STATE OF MAINE
DEPARTMENT OF TRANSPORTATION
16 STATE HOUSE STATION
AUGUSTA, MAINE 04333-0016

November 29, 2023
Subject: Bridge Deck Replacement
State WIN: 025631.01
Location: **Medway**
Amendment No. 6

Remove page 139 Bearing Details dated 10/5/23 totaling one page and **Replace** with the attached Bearing detail totaling one page dated 11/28/23

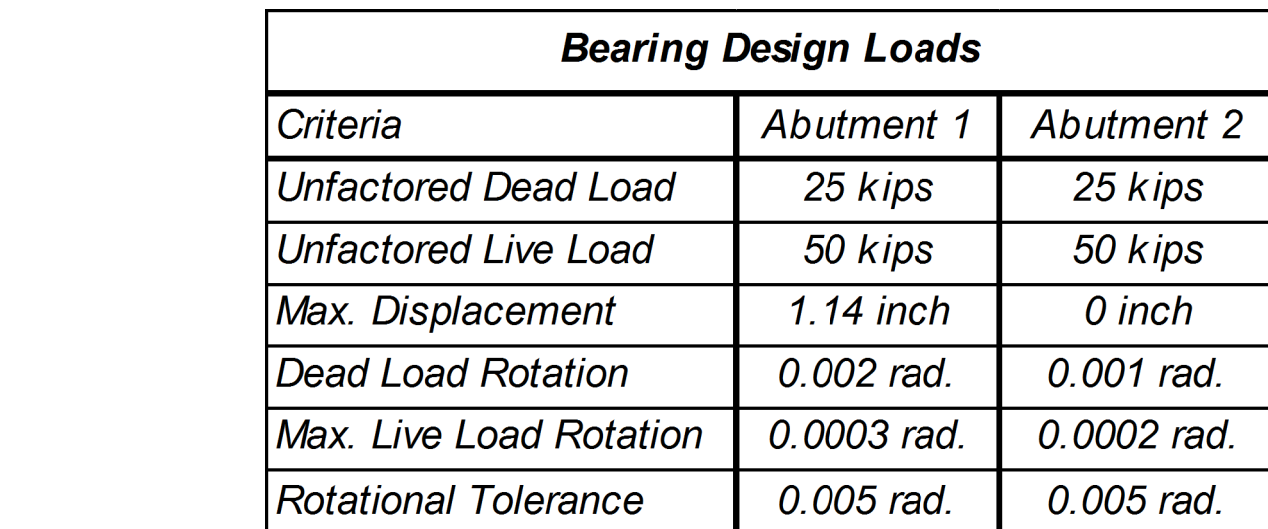
Question: On plan sheet 139 of 168, the expansion elastomeric bearing assembly detail calls for a vulcanized bond not only between the elastomeric bearing pad and sole plate but also between the bearing pad and the masonry plate. Is the bond between the pad and masonry plate necessary? considering the masonry plate is recessed? We cannot bond to this plate considering minimal clearance between the shear blocks and the pad itself and we request this bond be eliminated.

Response: **REMOVE** SHEET NUMBER 139 of 168, BEARING DETAILS dated 10/25/2023 and **REPLACE** with the attached SHEET NUMBER 139 of 168, BEARING DETAILS dated 11/28/2023. This revised sheet makes the following changes to the expansion bearing: removes vulcanization to the masonry plate and reduces the thickness of the bottom layer of elastomer.
